Access Compliance Report

Public Rights-of-Way

Intersection ID: 10019902	Main Street: ARCO_CORPORATE_DR	Cross Street: N/A	Location: SW
ADA ID: CD6300E81B27	Ramp Type: PerpDiag	Initial Pass/Fail: Fail	Overall Compliance: No
		Severity Score: 22.5

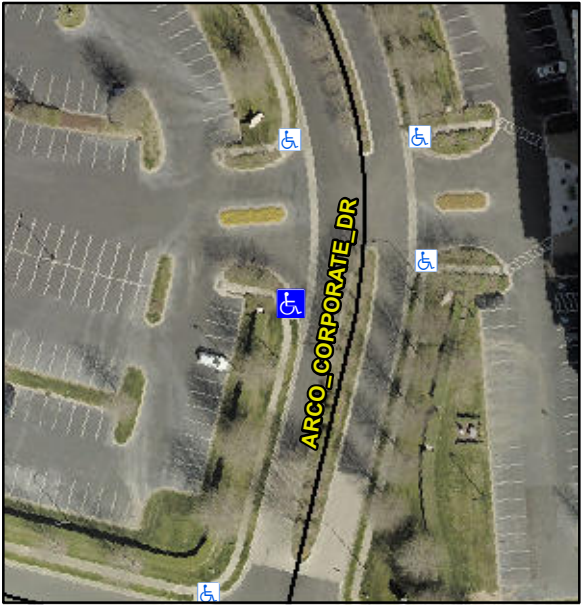
Codes/Mitigation Info/Possible Solution			Field Measurements/Component Compliance		
	Possible Solutions:		Compliance	Description	Data
	Remove & Replace Curb Ramp With Two New Directional Ramps or Equivalent.		No	Ramp Length (in)	48.0
			No	Ramp Width (in)	46.0
			N/A	Flare Type LT	N/A
			N/A	Flare Slope LT (%)	N/A
			N/A	Flare Traversable LT?	N/A
			N/A	Landing Length (in)	N/A
			N/A	Landing Width (in)	N/A
			N/A	Landing Slope (%)	N/A
			N/A	Landing X Slope (%)	N/A
<p>Surveyor Notes:</p> <p>N/A</p> <p>PROW/ADA:</p> <p>Not Found, R304.5.1, R304.2.2, R304.5.3</p>			N/A	Flare Type RT	N/A
			N/A	Flare Slope RT (%)	N/A
			N/A	Flare Traversable RT?	N/A
			N/A	DWS Provided?	N/A
			N/A	DWS Contrast?	N/A
			N/A	DWS Length (in)	N/A
			N/A	DWS Full Width?	N/A
			N/A	DWS Offset (in)	N/A
			N/A	Gutter Ponding?	N/A
			N/A	Gutter Lip Ht (in)	N/A
<p>Total Cost:</p> <p>\$ 3200.00</p>			No	Painted X Walk1?	No
			To E	X Walk 2 Direction	To N

N/A	X Walk 2 Width (in)	N/A
			1.9	X Walk 2 Slope (%)	4.1
			3.8	X Walk 2 X Slope (%)	1.5
			N/A	Ramp inside XWalk2?	N/A
			2.5	Clear Space?	N/A
			1.8	Clear Space to XWalk (in)	N/A
			N/A	Storm Grate/Utility Hazard?	N/A
			N/A	Storm Grate/Utility Type	N/A
			N/A	Surface Condition? (G/P)	Good
